BEFORE THE MINNESOTA PUBLIC UTILITIES COMMISSION

In the Matter of the Application for a Site Permit Amendment to Repower the Existing 30.75-Megawatt Community Wind South Wind Project in Nobles County, Minnesota.

PUC Docket No. IP-6871/WS-11-863

COMMENT AND PROPOSED FINDINGS OF FACT AND CONCLUSIONS OF LAW

Wind Access Buffer Setback Waiver Request Map

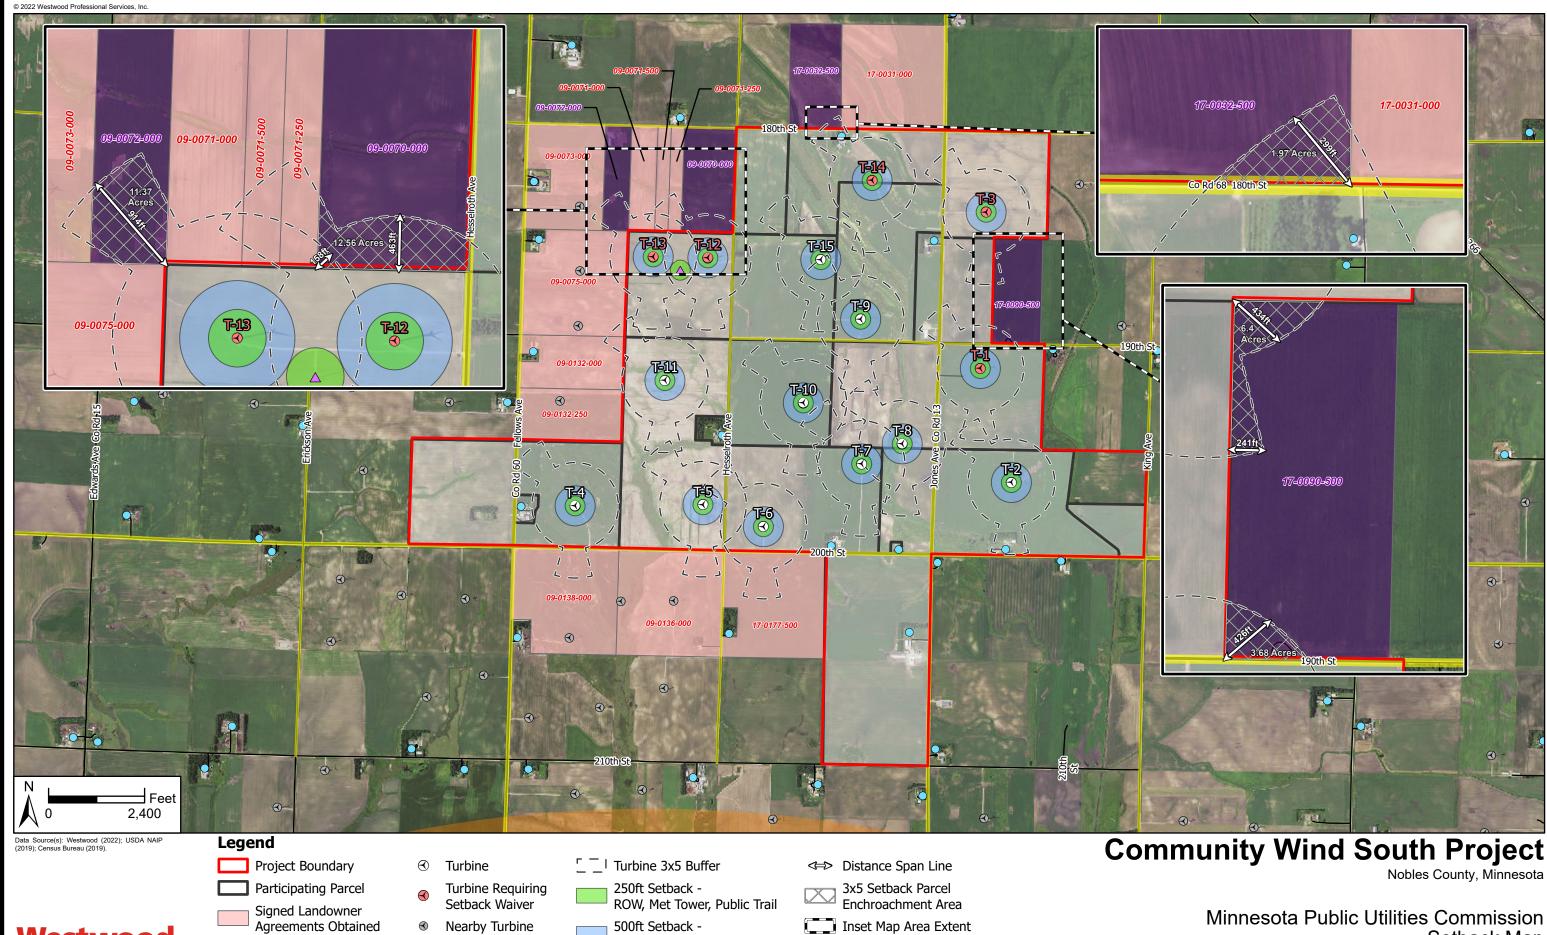
As noted above and in the Application, Zephyr anticipates obtaining participation agreements from all landowners within the Project's wind access buffer setback areas, as expanded to accommodate the repowering. As of the date of this Comment, Zephyr has obtained signed agreements from all such landowners except for with respect to four parcels: Parcel 09-0072-000 (affected by Turbine T-13), Parcel 09-0070-000 (affected by Turbines T-12 and T-13), Parcel 17-0032-500 (affected by Turbine T-14), and Parcel 17-0090-500 (affected by Turbines T-1 and T-3). The affected parcels and turbines are shown on the map attached hereto as Attachment 2.

Zephyr will continue to diligently pursue negotiations to reach commercially reasonable agreements with the remaining landowners, but in the event such negotiations are unsuccessful, Zephyr requests that the Commission grant wind access buffer setback waivers for Turbines T-1, T-3, T-12, T-13, and T-14. The locations of the turbines will not change as a result of the repowering, and, to Zephyr's knowledge, none of the affected landowners have raised objections to the repowering plans.

The Commission authorizes a variance of the wind access buffer setback for the following turbine locations: 5 turbines, including turbines: T-1, T-3, T-12, T-13, and T-14.
